BEFORE THE PATENT TRIAL AND APPEAL BOARD

Appeal 2014-009211  
Application 12/788,700  
Technology Center 3600

DECISION ON APPEAL

Figure 10 from Appellants' Specification is reproduced below.

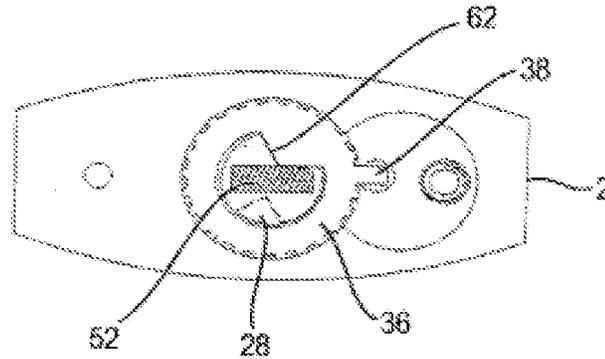
The Examiner objects to the drawings under 37 C.F.R. § 1.83(a) for failing to show every feature of the invention specified in the claims. Non-Final Act. 2. In particular, the Examiner finds that “the pin being arranged entirely outside a plane defined by the blocking plate must be shown or the feature(s) canceled from the claim(s),” cautioning that “[n]o new matter should be entered.” *Id.* The Examiner determines that the figures in the Specification do not show “the extents of the pin and the extents of the blocking plate.” Ans. 2.

Appellants argue that Figure 10 depicts the pin arranged entirely outside a plane defined by the blocking plate. Appeal Br. 7–8. In support, Appellants submit that paragraph 65 of the Specification discloses that “pin 24 also includes engagement elements 28 and 28” and that Figure 10 depicts that “engagement element 28’ is hidden by a portion of blocking plate 36.” *Id.* Moreover, Appellants submit that paragraph 83 of the Specification discloses that “‘engagement element 28’ is located *behind* the region 42 of the blocking plate 36’ such that the pin 24 is arranged *entirely* outside a plane defined by the blocking plate.” *Id.* Appellants conclude that “[b]ecause engagement element 28 is hidden by blocking plate 36, the pin 24 including engagement element 28 must be arranged entirely outside a plane defined by the blocking plate, as claimed.” *Id.* Appellants also rely on Figure 15 of the Specification, as depicting that “only one of the engagement elements (no reference number) of the pin 24 is visible through the aperture of the blocking plate 36 because the other ‘engagement element’ is hidden by the pie-shaped piece of the blocking plate 36[,]” concluding that “this oblique view clearly shows that the ‘pin [24] is arranged entirely outside a plane defined by the blocking plate [36].” Reply Br. 4 (also citing Spec., Fig. 15).

We determine that a preponderance of the evidence supports that Figures 10, 14, and 15 depict pin 24, including engagement elements 28, 28', as being arranged entirely outside a plane defined by blocking plate 36, as recited in claims 1 and 19. The description of pin 24 and blocking plate 36 in the Specification is consistent with this interpretation of the figures. The Specification describes entrainer formations 54, 54' of cylinder core 50 "extending *through* the opening 40" of the blocking plate, such that entrainer formations 54, 54' "lie at least partly in the same plane" as engagement elements 28, 28' of ball pin 24 and abut engagement elements 28, 28' to transmit rotational movement of cylinder core 50 to ball pin 24. *See* Spec. ¶ 75 (emphasis added). The Specification also discloses that surfaces 62, 64 of blocking plate 36 abut entrainment member 52, so that blocking plate 36 restricts movement of entrainment member 52. *See id.* ¶ 79 (citing Fig.6). The Specification does not disclose that engagement elements 28, 28' of pin 24 extend through opening 40 of the blocking plate to abut entrainer formations 54, 54' or that engagement elements 28, 28' of pin 24 abut surfaces 62, 64 of blocking plate 36, and thus, functionally, there is no support for the conclusion that engagement elements 28, 28' are arranged to intersect a plane defined by blocking plate 36. Moreover, as submitted by Appellants, the Specification describes that, during certain operations, "engagement element 28' is located behind the region 42 of the blocking plate 36," which would not be possible if engagement element 28 was in the same plane as blocking plate 36. *Id.* ¶ 83. Notably, none of the figures of the Specification depicts pin 24, including engagement elements 28, 28', extending *into* the plane of blocking plate 36; rather, the Specification expressly discloses that "[i]t is particularly preferred for padlocks in which replacement of the shackle is possible if the pin is arranged completely outside the plane of the blocking plate in accordance with the invention." *Id.* ¶ 33.

Accordingly, we do not sustain the Examiner's objection to the drawings.

Figure 10 depicts a bottom view of lock body 2, including engagement element 28 of ball pin 24 and blocking plate 36. Figures 14 and 15 of Appellants' Specification are also reproduced below.

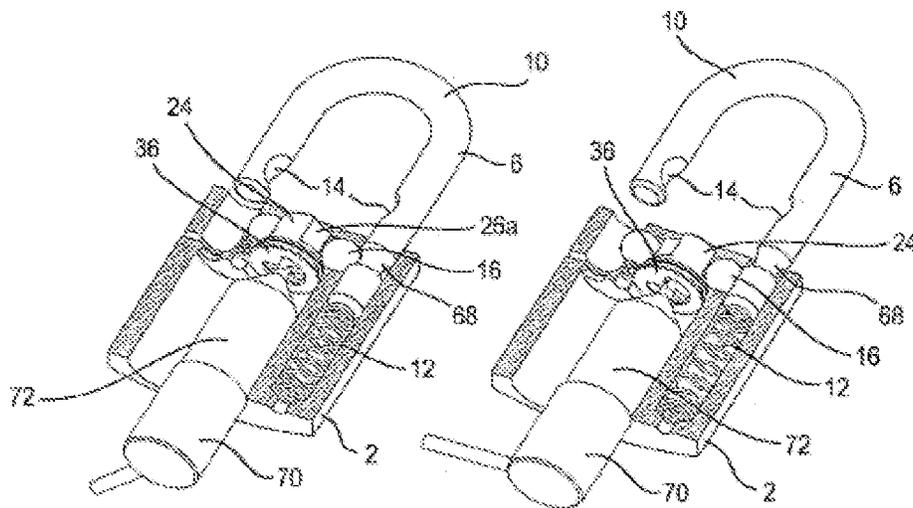
Figures 14 and 15 depict sectioned views of a padlock, with tool 70 in first and second positions, respectively.
